VILLAGE OF ESTERO ZONING STAFF REPORT

CASE TYPE: ADMINISTRATIVE AMENDMENT
CASE NUMBER: ADD 2016-E006
CASE NAME: SPRINGS AT GULF COAST
PLANNING & ZONING BOARD DATE: June 21, 2016

SPRINGS AT
 GULF COAST

PARKING EXHIBIT

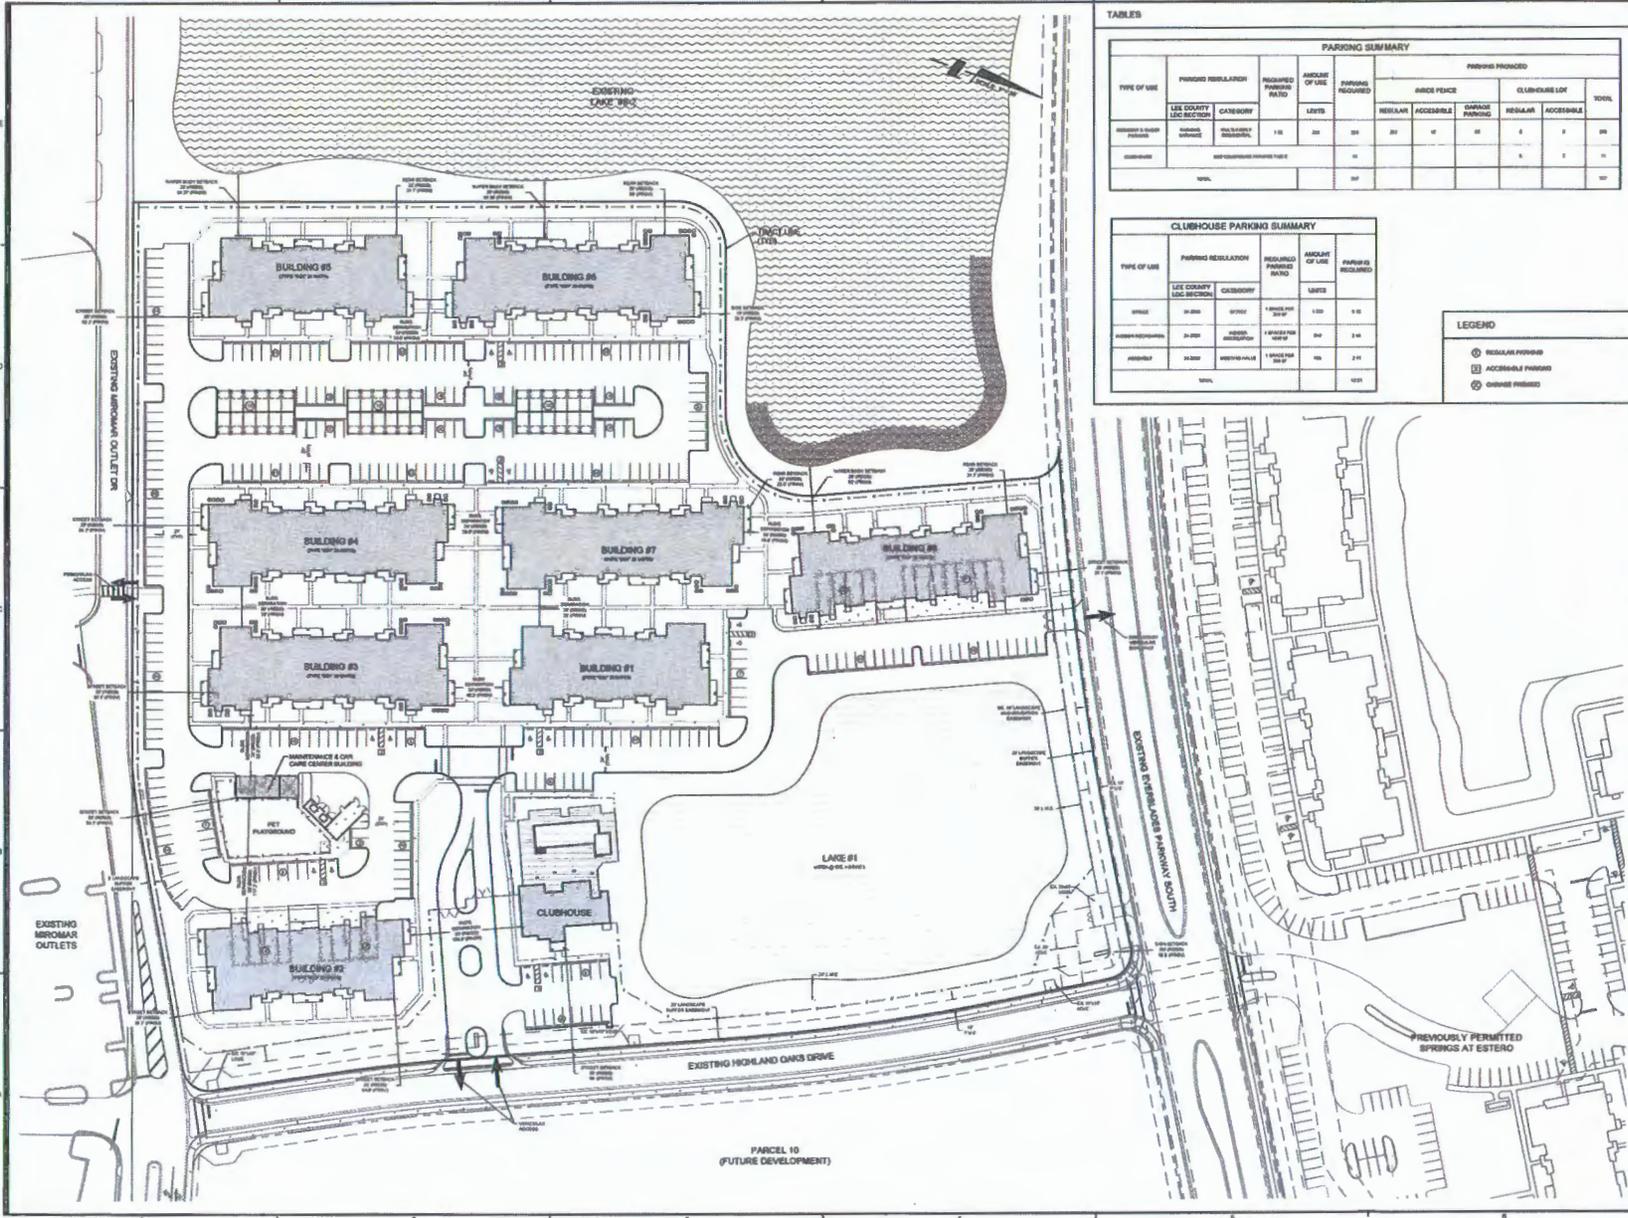
The applicant requests a parking space reduction to 1.75 parking spaces per unit rather than the required 2 parking spaces per unit. This reduction would reduce the total required amount from 447 parking spaces to 356 parking spaces. The 356 parking space total does not include the additional 10% (36 parking spaces) required for guest parking. A total of 392 parking spaces would be required by Section 34-2020 (a) of the County Land Development Code.

It appears that a parking reduction could be justified, if the Applicant adds the 10% for guest parking. If the Planning and Zoning Board is in favor of approving the request, staff recommends the conditions in the attached resolution.

- 74 1. The terms and conditions of the original Zoning Resolution (Z-97-010) remain in
75 full force, except as modified herein.
76
- 77 2. The total number of parking spaces to be provided is 392 (356 plus 10% for guest
78 parking). Parking space locations must be in substantial compliance with Site
79 Plan, Drawing Number C-101.
80

- 81 3. The Applicant is required to provide 11 parking spaces for the proposed
82 clubhouse, as depicted on the Site Plan, Drawing Number C-101.
83
- 84 4. The Applicant must provide assigned parking for the proposed parking spaces on
85 the Development Order plans.
86
